# Technical Bulletin

## Subject: DISH Network's Reconfiguration of the 129°W Satellite

### Products Affected

TracVision® C3, M5, and M7

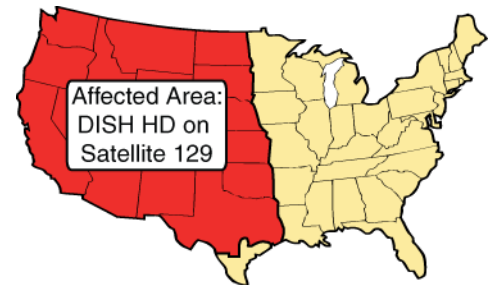
DISH Network® will change the frequency encoding of its 129°W satellite as early as **Wednesday, December 16<sup>th</sup>**. This change will affect all mobile DISH Network TurboHD subscribers in the western half of the United States, regardless of which manufacturer's antenna they are using.

Once DISH Network implements this change, TracVision C3, M5, and M7 antenna systems will not be able to track the 129°W satellite without the new hardware accessory described below.

This DISH Network change only affects DISH 1000/129 automatic mode in TracVision C3, M5, and M7 antennas. All other operating modes, including DISH 1000/61, DISH 500, DIRECTV®, ExpressVu (Bell TV service), and all manual modes (e.g., multiswitch configurations), are unaffected by this problem. This problem also does not affect the 119°W and 110°W satellites; customers will still be able to enjoy standard-definition DISH programming from these two satellites without any issues.

KVH has developed a new enhanced multiswitch called the Master Receiver Selector that completely resolves any issues related to the 129°W satellite, while providing additional capabilities.

- Automatic satellite switching in any DISH Network mode
- Support for multiple receivers
- Capability for the user to select, at any time, which "master" receiver will control satellite selection

*Note: Changes by satellite TV providers are not covered by KVH's warranty. Customers are responsible for purchased hardware and dealer installation/labor charges. Also note that both RF1 and RF2 cables from the antenna will need to be connected to the Master Receiver Selector.*
